Access Compliance Report Public Rights-of-Way (Curb Ramps)

Main Street: CEDARLAWN_DR Cross Street: LUTE_AVE Location: NE

ADA ID: RPAT21112152800 Ramp Type: Type 1 - Perpendicular Diagonal Initial Pass/Fail: Pass Overall Compliance: No Severity Score: 2

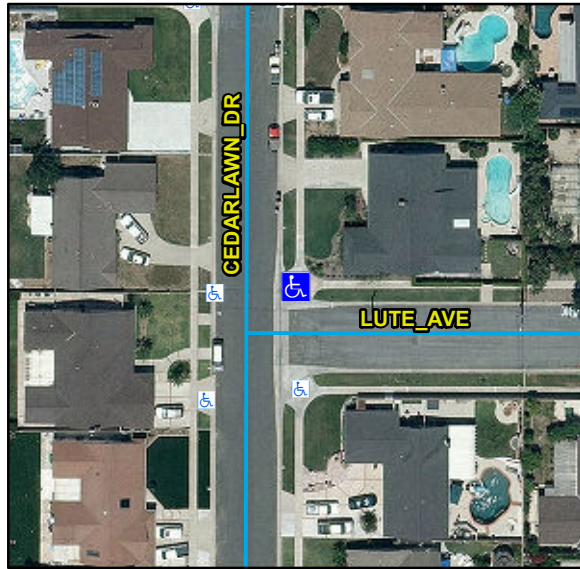
Possible Solutions:

Remove & Replace Curb Slope.

N/A	Ramp Inside Crosswalk 1	N/A	Yes	Ramp Inside Crosswalk 2	N/A
	Crossing 1 Slope (%)	6.5		Crossing 2 Slope (%)	2.1
	Crossing 1 Cross Slope (%)	0.6		Crossing 2 Cross Slope (%)	2.6
Yes	Gutter Ponding	No	No	Curb Slope	7
Yes	Gutter Lip Height (in)	0		Road Run Slope (%)	0.1
Yes	Gutter Run Slope (%)	2.4		Road Cross Slope (%)	4.2
Yes	Gutter Cross Slope (%)	0.2			
Yes	Overall Surface Condition: Acceptable		Yes	Perp Joint Present	Yes
	Cross Gutter Present?	Yes		Spandrel Present?	Yes
	Replace Cross Gutter?	No		Replace Spandrel?	No

R304.2.2, STD 1115
